ADDENDUM #1

Reference: Layton Court HVAC Upgrades
Administrative Office of the Courts – Layton, Utah
Project No. 08047150

Enclosed are the items to be included for Addendum 1 for the DFCM project 08047150 Layton District Court AHU Replacement Project.

REFERENCE PLAN: EXISTING MAIN FLOOR MECHANICAL PLAN

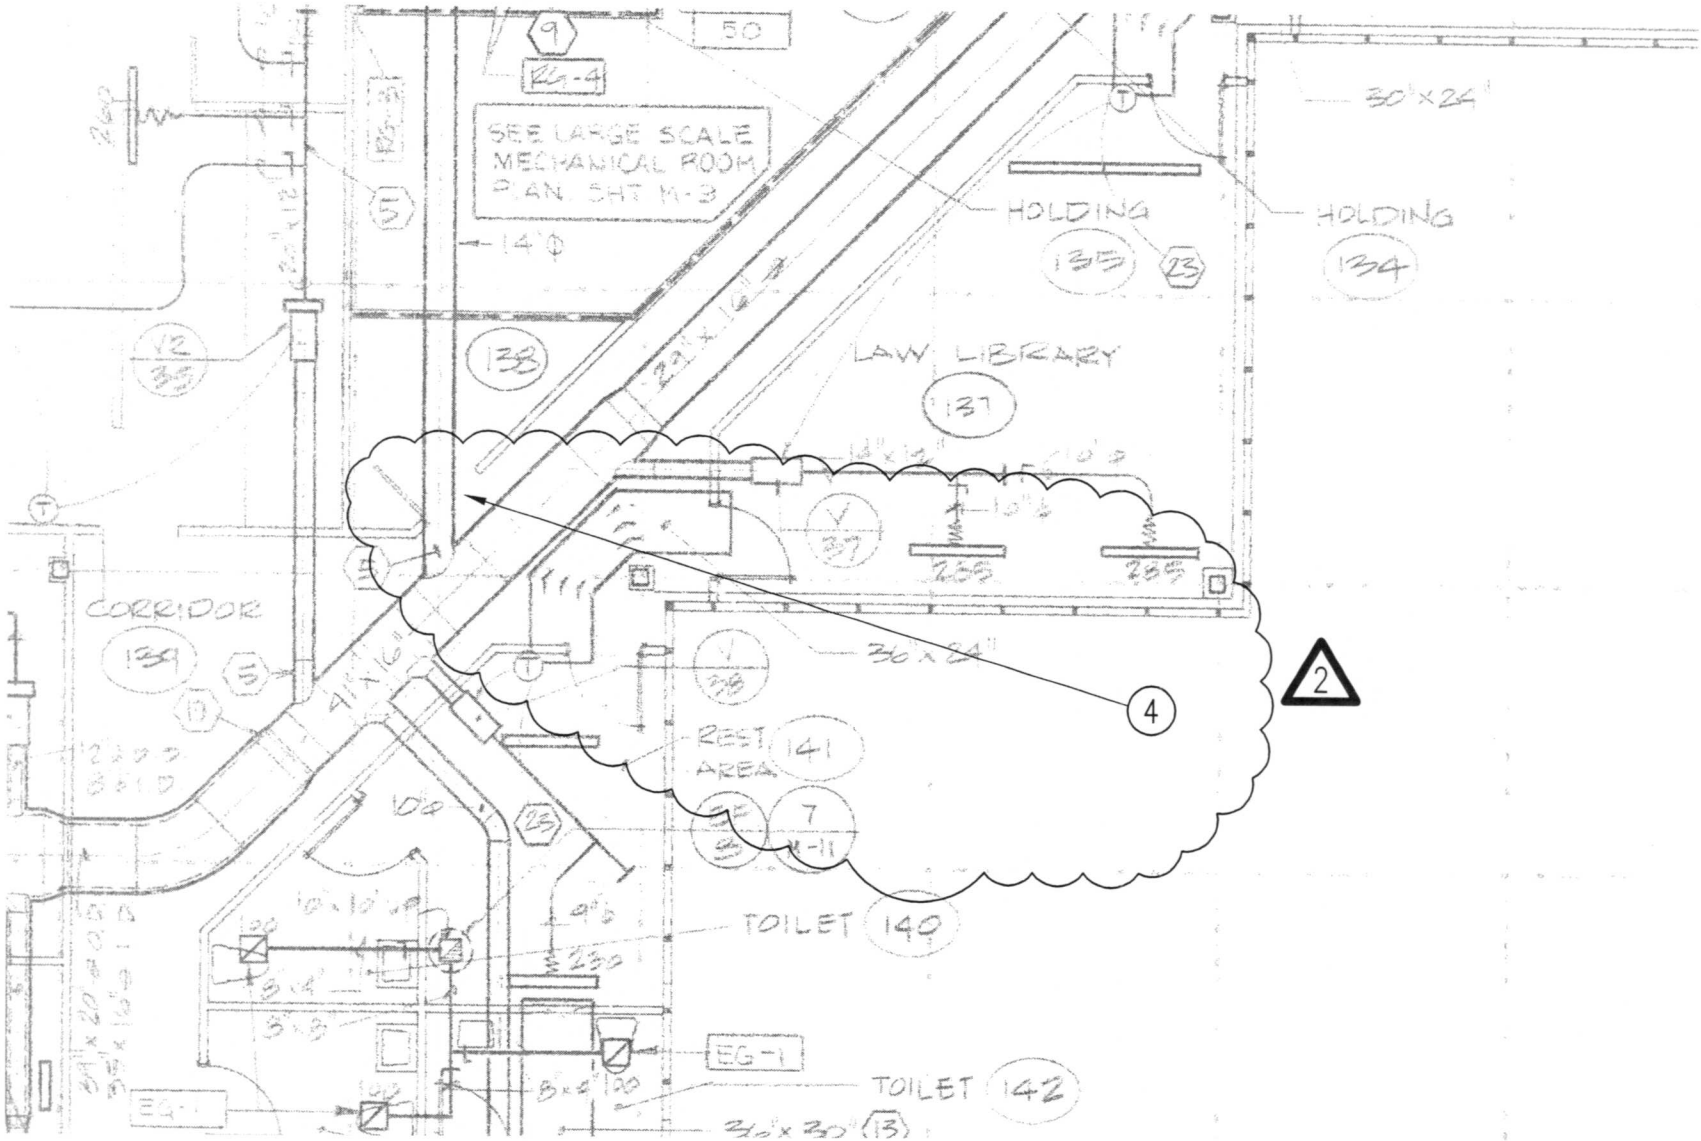
1. See attached partial plan of sheet MG3 with regard to adding a door closer.
2. See attached partial plan of sheet EG2 with regard to revised Key Notes 1 & 2.
3. See attached partial plan of sheet EG3 with regard to revised Key Note heading.
4. See attached partial section 23 74 00 with regard to roofing material and contracting associated with demolition and replacement of mechanical equipment on the roof.

4. THE CONTRACTORS SHALL REPLACE THE EXISTING AUTOMATIC DOOR CLOSER IN STORAGE ROOM 138 SO THAT THE NEW DOOR CLOSER LINKAGE WILL NOT BE A SAFETY HAZARD TO THE PERSON CLIMBING THE ROOF ACCESS LADDER. THE NEW DOOR CLOSER SHALL BE A TRACK RAIL ARM STYLE OR SIMILAR WITH THE LINKAGE ARM PARALLEL TO THE FACE OF THE DOOR WHEN THE DOOR IS CLOSED. THE NEW AUTOMATIC DOOR CLOSER SHALL BE BY STANLEY, BEST, OR APPROVED EQUAL.
